CITY OF ALBUQUERQUE

RE: Sandia Area Federal Credit Union-Starbucks 13101 Montgomery NE Requested for 30 Day Temporary C. O. - Accepted Engineers Stamp Date 7/1/15 (F22D002)

DRAINAGE AND TRANSPORTATION INFORMATION SHEET

_18'' wide x 2' deep trench filled with crushed angular rock 3/4-2" average size, install 12" hdpe perforated

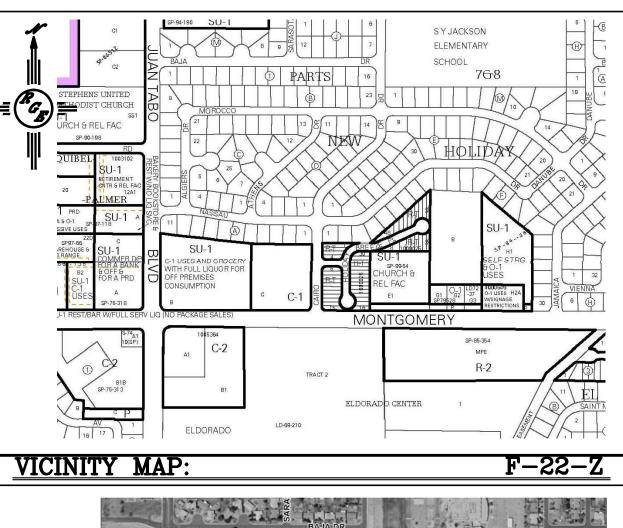
- Albuquerque
- The sidewalk culvert extends thru the First Flush Trench thereby blocking the flow. The sidewalk culvert must be cut back and stop at the edge of the sidewalk as shown on the approved drawing.
